SERVICE LETTER NO. 74-4

DATE: MAY 8, 1974

SUBJECTS: ITEM 1. WINDSHIELD/CANOPY ATTACH SCREW TORQUE
ITEM 2. CANOPY LATCH IMPROVEMENT
ITEM 3. CARBURETOR HEAT/MIXTURE CONTROL FITTING IMPROVEMENT
(SUPERSEDES SL71-10)
ITEM 4. FUEL TANK VENT INSPECTION AND MODIFICATION
ITEM 5. INSPECTION COVER INSTALLATION
ITEM 6. AVCO LYCOMING SERVICE INSTRUCTION NO. 1266

FIGURE 1. FUEL TANK VENT INSPECTION AND MODIFICATION

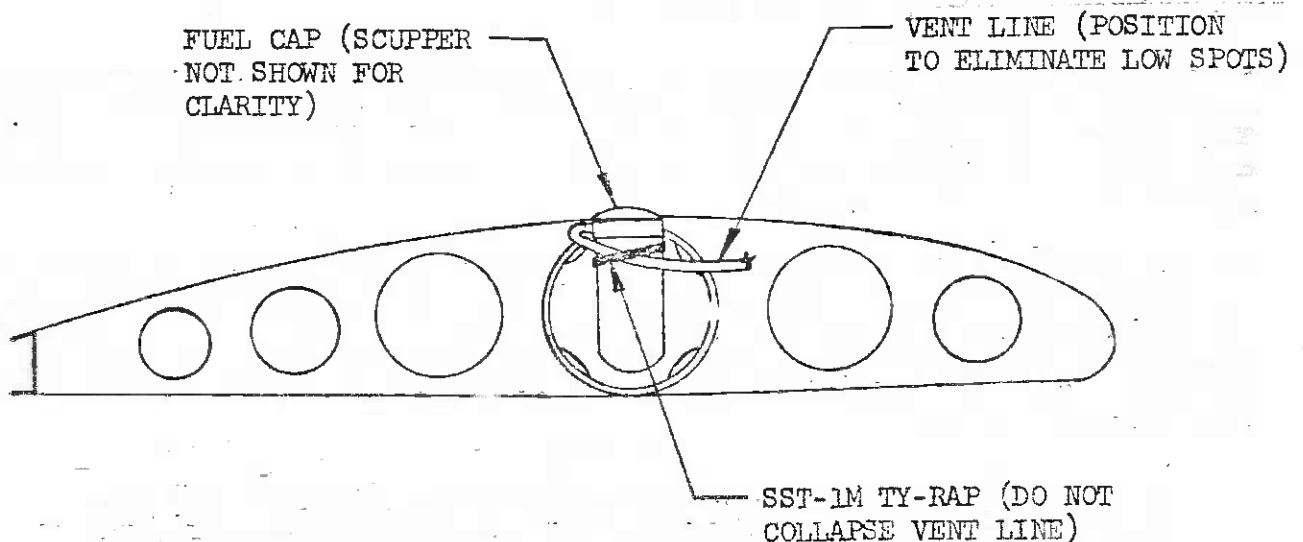
To preclude the possibility of an accumulation of moisture and subsequent freezing in a low spot in the right-hand wing outboard vent line, the following inspection should be performed within the compliance time suggested.

Remove the right-hand wing tip and note the PVC vent line that connects to the fuel tank filler neck and the tube leading to the vent drain. If a low spot exists in this line, or if due to sagging, a low spot could develop, the line should be secured to the tank filler neck with part number, SST-1M Ty-rap or equivalent. The Ty-rap should support the vent line to prevent low spots, however, the Ty-rap should not be tightened to such an extent that the vent line will collapse.

See Figure 1 for Ty-rap location.

FIGURE 2. INSPECTION COVER INSTALLATION
(BOTTOM VIEW OF RH WING SHOWN)

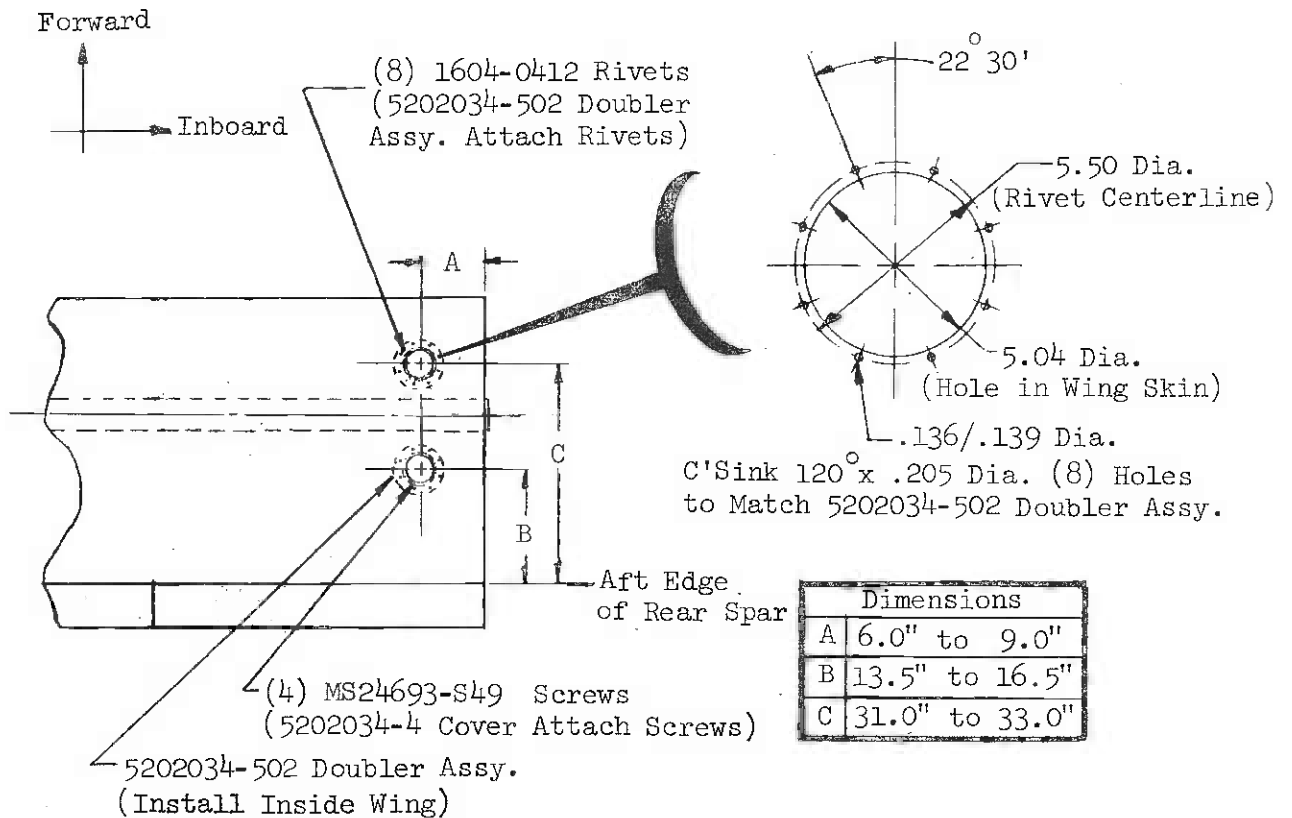
Access to the four wing lock bolts and fuel outlet fittings may be improved by the installation of an access cover and associated doubler below each wing lock bolt on the lower surface of each wing. This installation will provide a 4" diameter hole, which simplifies inspection of the wing lock bolt torque and facilitates the wing removal and installation procedure. The following items are required for the installation of four (4) access covers (two (2) per wing): four (4) 5202034-4 Cover; four (4) 5202034-502 Doubler Assembly; sixteen (16) MS24693-S49 Screw; (32) 1604-0412 Rivet.

Installation details are shown in Figure 2.
